Access Compliance Report

Public Rights-of-Way

(Curb Ramps)

Intersection ID: 14596	Main Street: SOUTH_BV	Cross Street: MAGNOLIA_AV	Location: S
ADA ID: 6409494D415C	Ramp Type: PerpDiag	Initial Pass/Fail: Fail	Overall Compliance: No
			Severity Score: 13.75

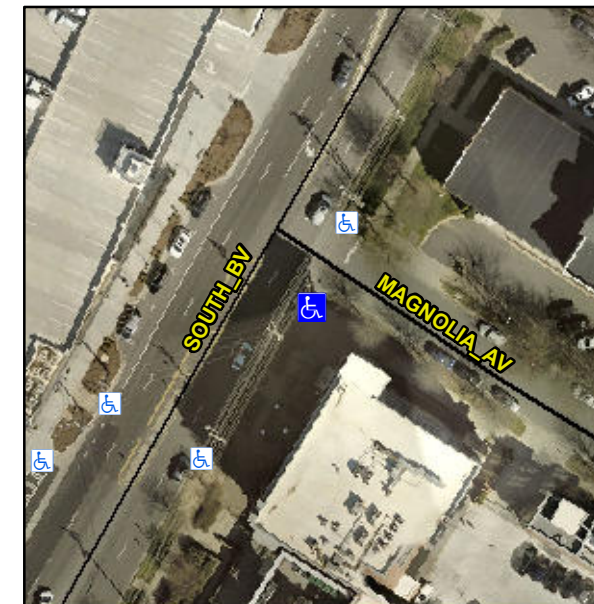
Not Found, R304.2.2, R304.5.3

Compliance	Description	Data	Compliance	Description	Data
N/A	Ramp Length (in)	74.0	No	Ramp Slope (%)	8.6
Yes	Ramp Width (in)	49.0	No	Ramp XSlope (%)	3.9
N/A	Flare Type LT	N/A	N/A	Flare Type RT	N/A
N/A	Flare Slope LT (%)	N/A	N/A	Flare Slope RT (%)	N/A
N/A	Flare Traversable LT?	N/A	N/A	Flare Traversable RT?	N/A
N/A	Landing Length (in)	N/A	N/A	DWS Provided?	N/A
N/A	Landing Width (in)	N/A	N/A	DWS Contrast?	N/A
N/A	Landing Slope (%)	N/A	N/A	DWS Length (in)	N/A
N/A	Landing X Slope (%)	N/A	N/A	DWS Full Width?	N/A
N/A	Landing Curb? (Y/N)	N/A	N/A	DWS Offset (in)	N/A
N/A	Shared Landing?	N/A			
N/A	Gutter Ponding?	N/A	N/A	Gutter Slope (%)	N/A
N/A	Gutter Lip Ht (in)	N/A	N/A	Gutter X Slope (%)	N/A
N/A	Painted X Walk1?	No	N/A	Painted X Walk2?	No
	X Walk 1 Direction	To NE		X Walk 2 Direction	To NW
N/A	X Walk 1 Width (in)	N/A	N/A	X Walk 2 Width (in)	N/A
	X Walk 1 Slope (%)	0.2		X Walk 2 Slope (%)	5.4
	X Walk 1 X Slope (%)	4.9		X Walk 2 X Slope (%)	0.5

Remove & Replace Curb Ramp With Two New Directional Ramps or Equivalent.
